Submission to Department of Planning and Environment West Schofields Precinct Masterplan

PREPARED FOR MIRVAC HOMES (NSW) PTY LTD

Figure 2.1: DRAFT West Schofields – North West Growth Centre- Residential Density Map

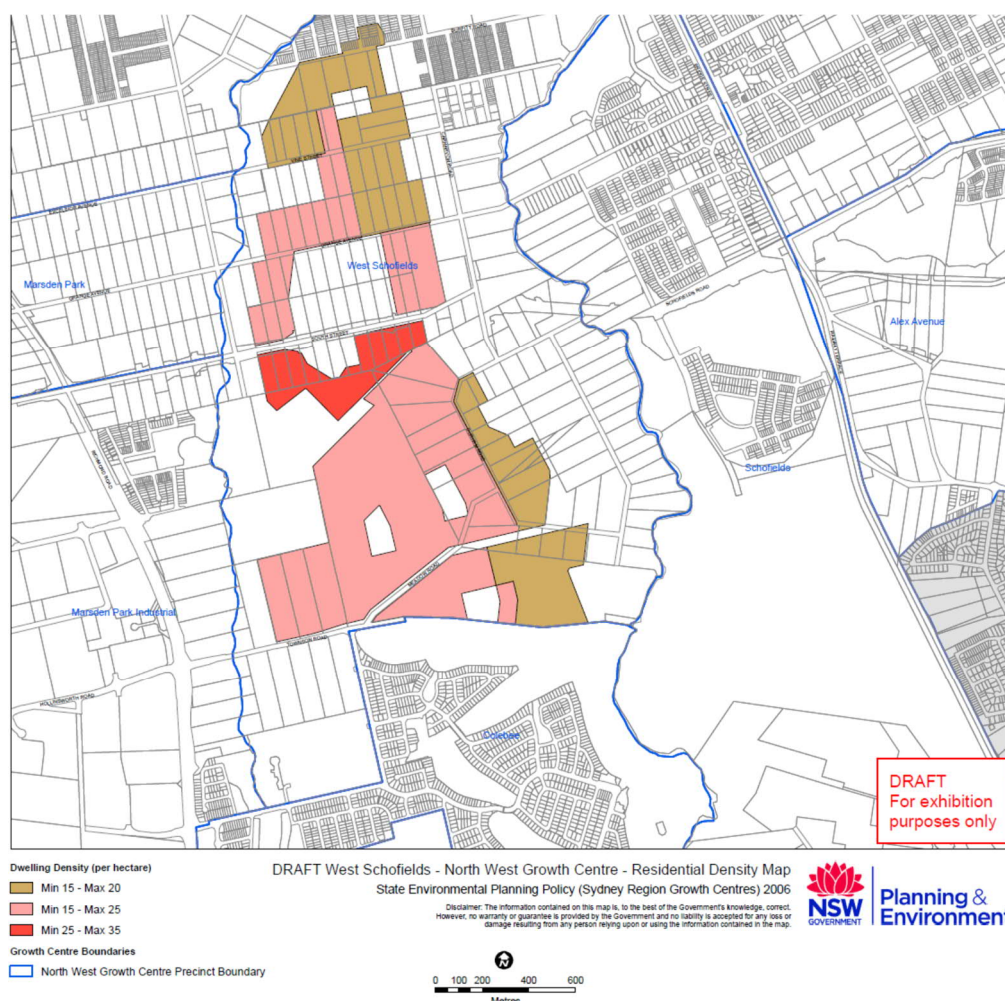
We note that the above wording implies that the Density Bands are controlled by the location of the PMF (i.e. first point referring to a density between 15 dwellings per hectare and 20 dwellings per hectare between the 1:100 year flood level and the PMF). However, the proposed Dwelling Density Maps do not match the line of PMF. In addition, a substantial portion of the land between the ARI 100 year and PMF flood levels is also above the 500 year levels identified in the Flooding, Water Cycle Management and Riparian Corridor Assessment. The wording of this clause puts substantial restriction on lands with a flood risk well below the accepted planning standards in New South Wales and with a small probability of occurrence during the lifetime of any buildings proposed as a result of the urban development of this area.

Mirvac supports the dwelling densities currently shown on the density map. The wording suggested in Clause 4.1 renders the site unviable to develop and restricts the potential of housing supply. We therefore recommend that the Dwelling Density Maps take precedence and the wording in Part 4.1 of Schedule 9 be amended to read:

The maximum total number of dwellings proposed for this precinct will occur via density capping. Three density bands are proposed (see Figure 11):

- *R2 Low Density Residential zone with a minimum 15 dwellings per hectare and a maximum 20 dwellings per hectare as shown on the plan,*
- *R2 Low Density Residential zone with a minimum 15 dw/Ha and a maximum 25 dw/Ha as shown on the plan,*
- *R3 Medium Density Residential zone with a minimum 25 dw/Ha and a maximum 35 dw/Ha as shown on the plan.*

Figure 2.2 – Extract from ‘Lots requiring filling’ figure from exhibited Calibre Water Cycle Management and Flooding technical study

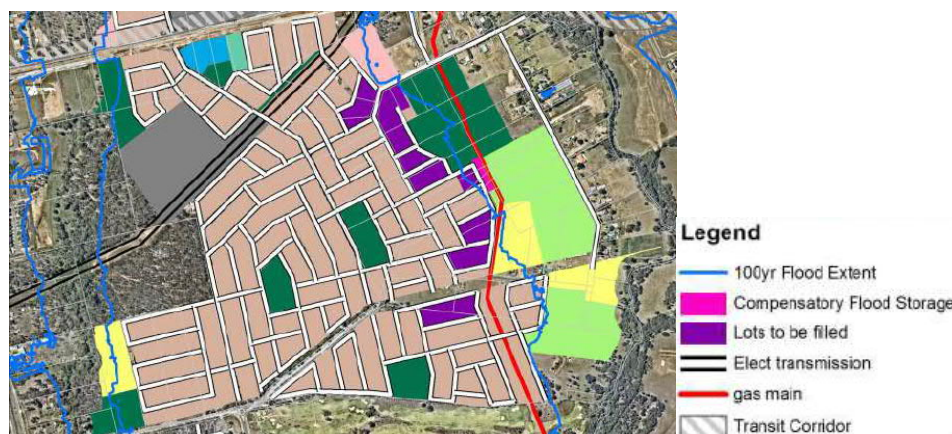
There are no DCP sections that discuss the possibility to fill land below the PMF and the impact this will have on the floodplain, for example lots highlighted in Figure 1 from the Watercycle Management and Flooding technical study.

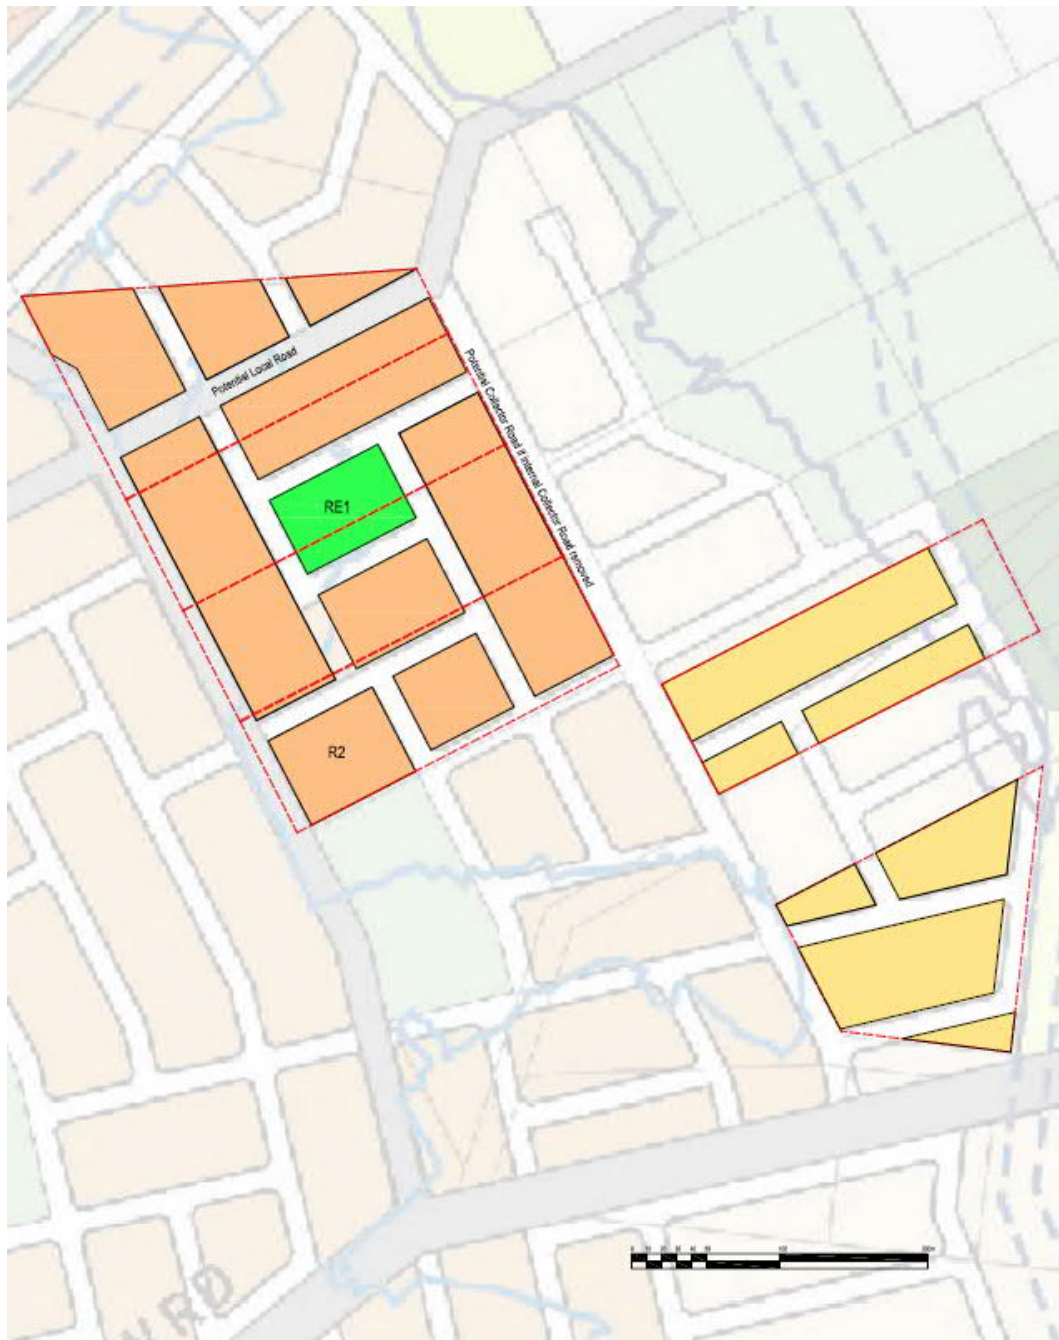
As discussed earlier, Mirvac has secured interest in several parcels as shown in Figures 1.2 and 1.3. Part of lot 32/12076 is proposed to be zoned RE1 and contribute to a larger RE1 parcel to the south. Mirvac are seeking to relocate the component of RE1 within Lot 32 in DP 12076 to the area shown in Lot 34 in DP 12076. The reasons for this are as follows.

- The relocated open space parcel is a like for like in size (approximately 0.5ha)
- The proposed open space area exceeds the minimum lot size of 0.3ha recommended by HillPDA in their report
- Based on Mirvac's extensive experience in designing, developing and ongoing community engagement within playground space, our data suggests that the 0.5 ha is an optimum size for meeting local playground needs.
- The location is capable of better accommodating the requirement to enable community access within 400m.
- the new location enables Mirvac to more effectively design built form outcomes adjacent to the park which will benefit from:
 - framing built form around the park
 - provision of compact housing options around amenity where they are appropriate
 - designing homes under safer by design principles offering passive surveillance opportunities between common space and homes

- better relationship between public and private open space.
- It offers a more efficient urban planning outcome by enabling multiple local and diverse open space options for the public

MULTI-DUO 13

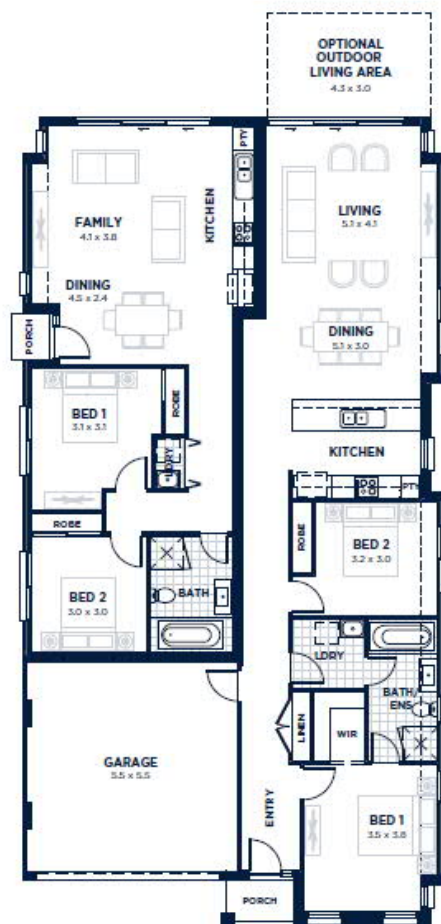
Great innovative solution to address housing affordability, diversity and supply but the constraint is the current policies do not promote this solution. However with minor amendments this could be implemented.

Interestingly the building footprint of the Multi-Duo product offering (largest final product in series) meets all the dwelling controls stated in the current State Environmental Planning Policy (Exempt and Complying Development Codes) 2008. This confirms that the house is not an overdesign. It also complies with the Draft Housing Code controls. Given the current environment of needing affordable housing supply it seems appropriate that this form of housing now sits within the State Environmental Planning Policy (Exempt and Complying Development Codes) 2008 rather than just State Environmental Planning Policy (Affordable Rental Housing) 2009. I understand that DPE are pursuing this.

Mirvac recommends the following minimum minor amendments be actioned to promote this type of housing.

- Secondary Dwellings are included in the State Environmental Planning Policy (Exempt and Complying Development Codes) 2008 (or updated draft housing codes) rather than just State Environmental Planning Policy (Affordable Rental Housing) 2009.

- Amend clauses in State Environmental Planning Policy (Sydney Region Growth Centres) 2006 to set minimum lot size for a secondary dwelling in a R2 zone to be 400sqm.

- Enable secondary dwellings to be permissible in all R2 zones in all LEP's in Sydney. This should be partly addressed if the dwellings are included in the Exempt and complying codes SEPP as proposed in top point. Ensure the minimum lot size for a secondary dwelling on land in Zone R2 Low Density Residential is 400m2
